TITEL: **Modifiering av förgasarens filterhus**

GÄLLER: Alla R22 modeller

LFS: 1990:26

90-17-01 ROBINSON HELICOPTER COMPANY (RHC): Amendment
39-6687. Docket No. 89-ASW-58.

90-17-01
FIGURE 1

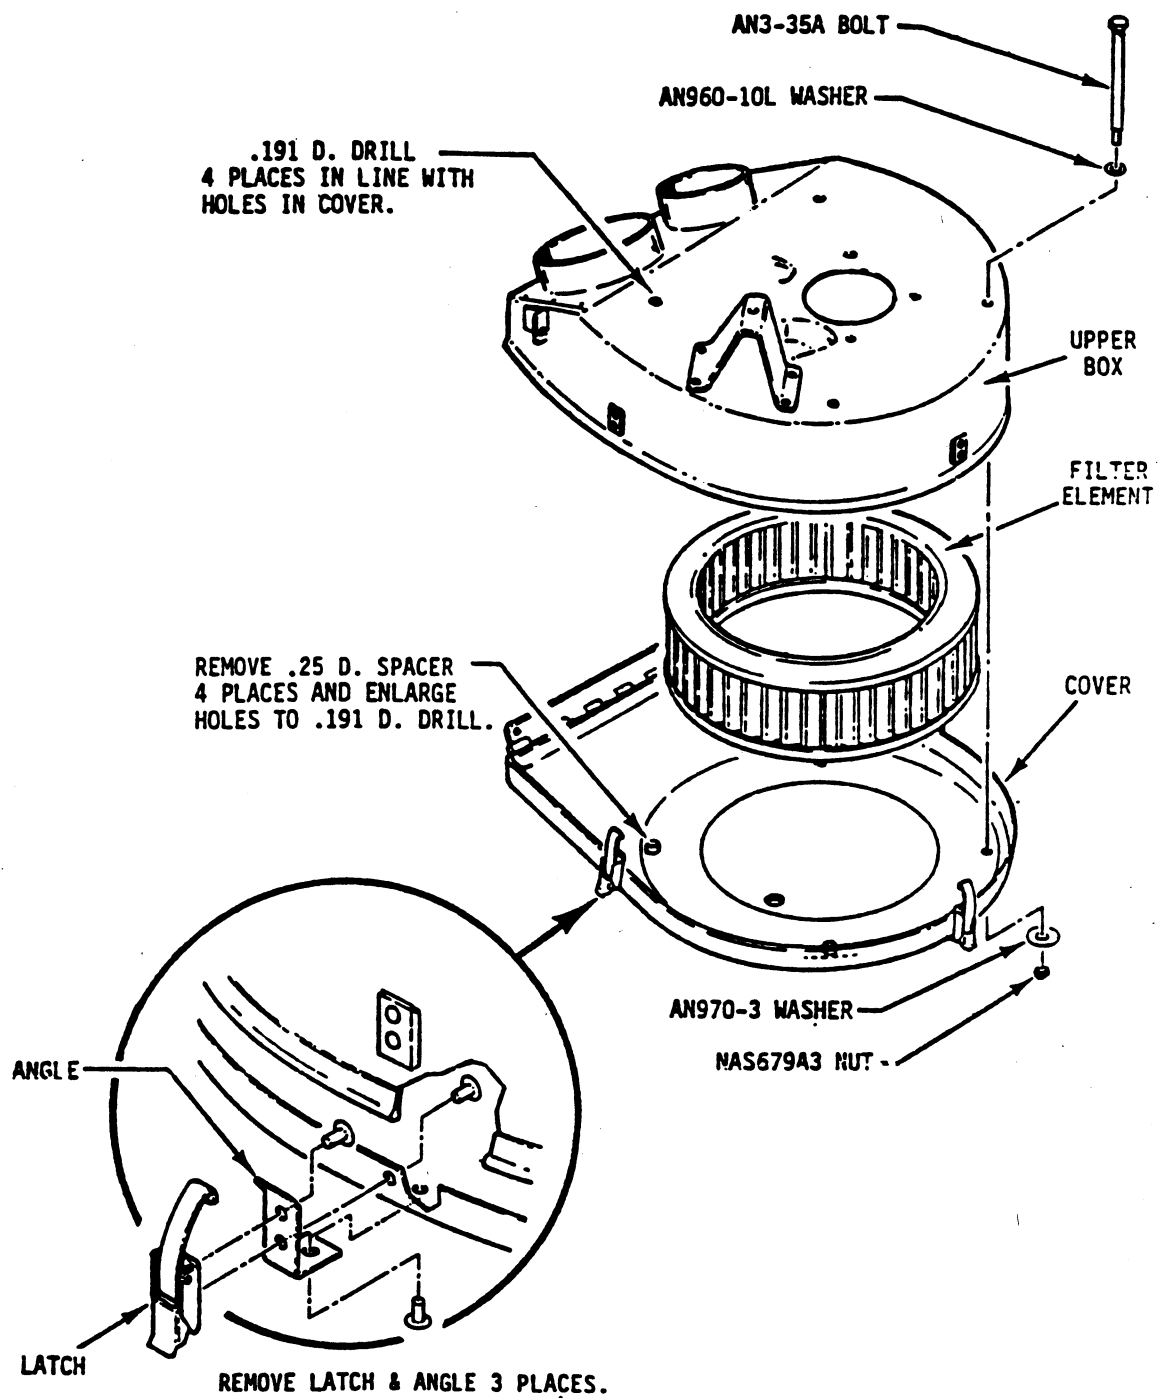
(a) Remove the three carburetor air box latches and replace with four bolts in accordance with the following:

- (1) Open the air box and remove the filter element.
- (2) Remove the air box from the helicopter.
- (3) Drill out the four rivets in the cover holding 0.25 inch diameter spacers and enlarge the holes to 0.191 inch diameter. Discard the spacers.

- (4) Close the cover, and using the holes in the cover as guides, drill four matching holes through the upper box in line with the holes in the cover.

- (5) Open the air box and drill out all the rivets holding the latches to the cover. Discard the latches and angles. Clean the drilling chips from the box.

- (6) Reinstall the air box to the helicopter.

- (7) Install the filter element and secure the cover using four AN3-35A bolts, AN960-10L washers, AN970-3 washers, and NAS679A3 nuts.

NOTE: Refer to Figure 1 for accomplishing the instructions required by paragraph (a).
